Product Change Notification

Change Notification #: 113625 - 00
Change Title: Intel® Server Chassis P4304XXSFCN and P4308XXMFEN
PCN 113625-00, Product Design, Label Update Hard Disk Drive Tray to add 2 latches and labels, and Update Regulatory Labels
Date of Publication: February 4, 2015

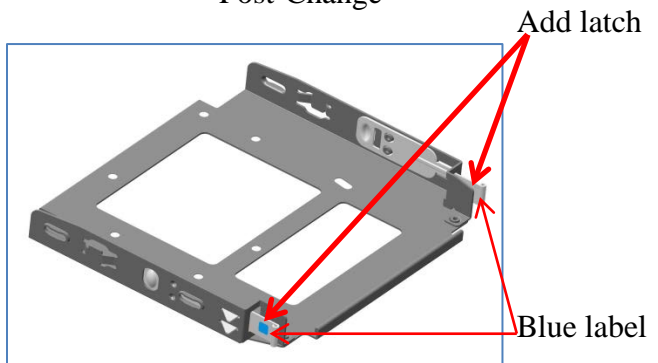
1. Add two latches and labels for the fixed HDD (Hard Disk Drive) tray to enhance the robustness of the HDD tray and indicate the touch point for the HDD tray assembly.

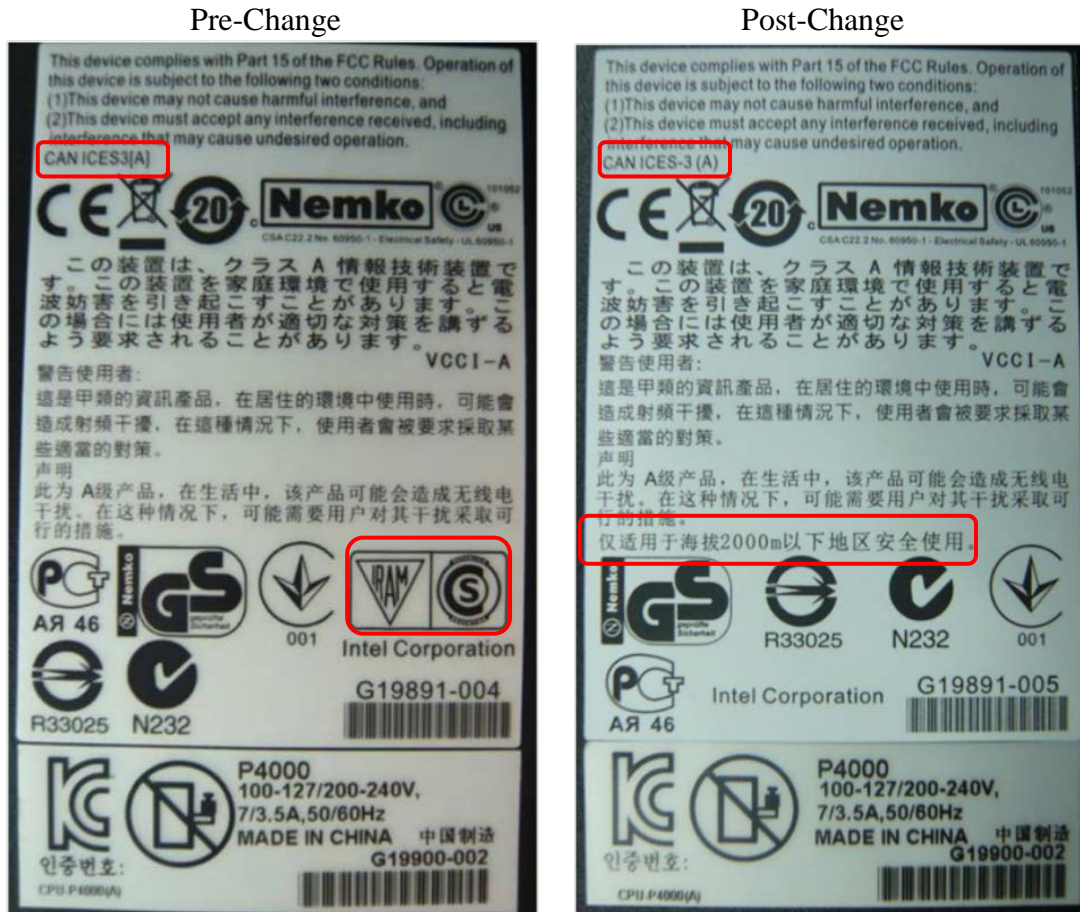
- Remove the safety label IRAM, update the Canada statement, and add an altitude warning in Chinese on the common regulation label.

- Remove the safety label IRAM and update the Canada statement on the outer carton label.
